Service Note

OLED replacement guide for OnAir series

V1.01

Appendix 1

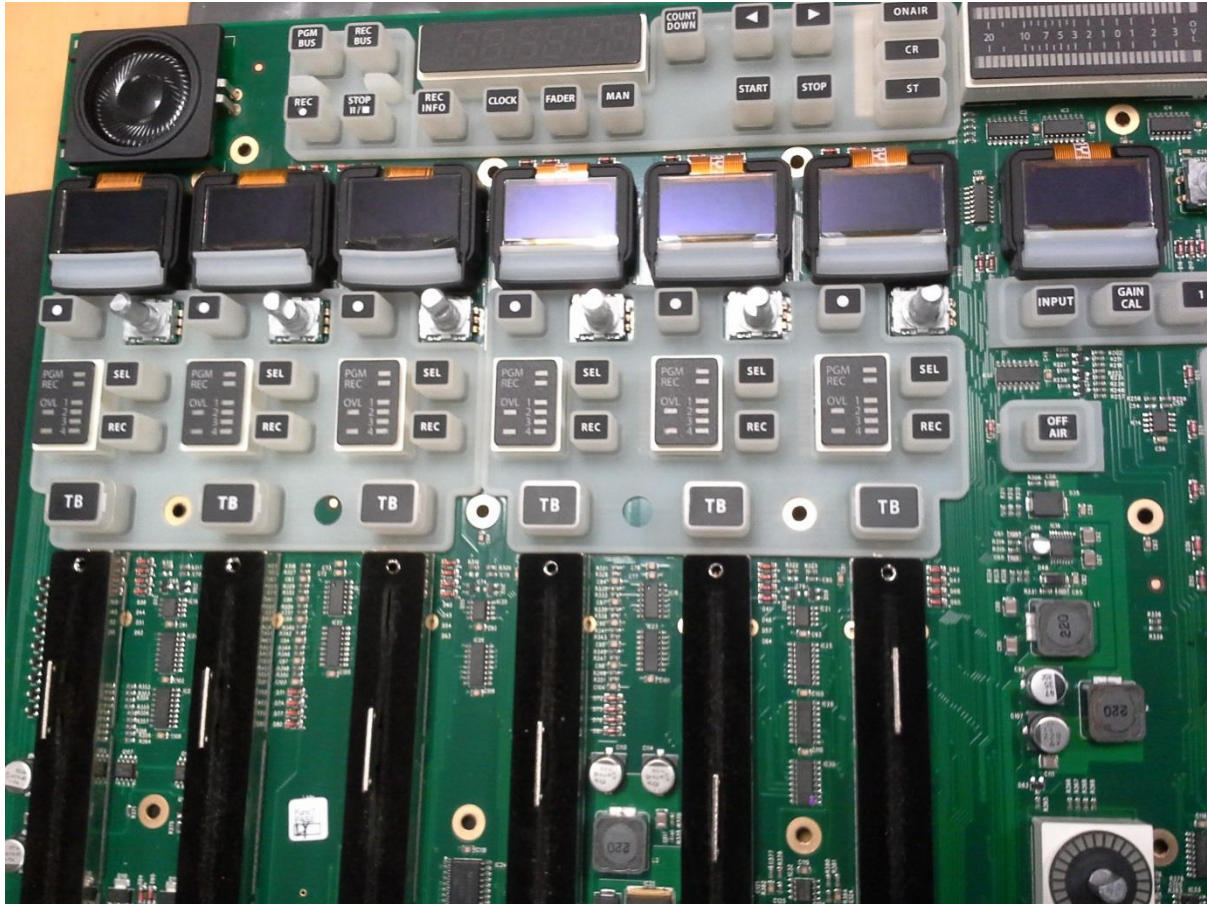
This photo demonstrates the differences of the OLED's on an OnAir 1500 6-fader module

Strip channel 1-2 has a new OLED with new type with a new rubber pad and lightpipe.

Strip channel 3 has a new OLED with old holder and lightpipe

Strip channel 4-6 has an old OLED with old holder and lightpipe.
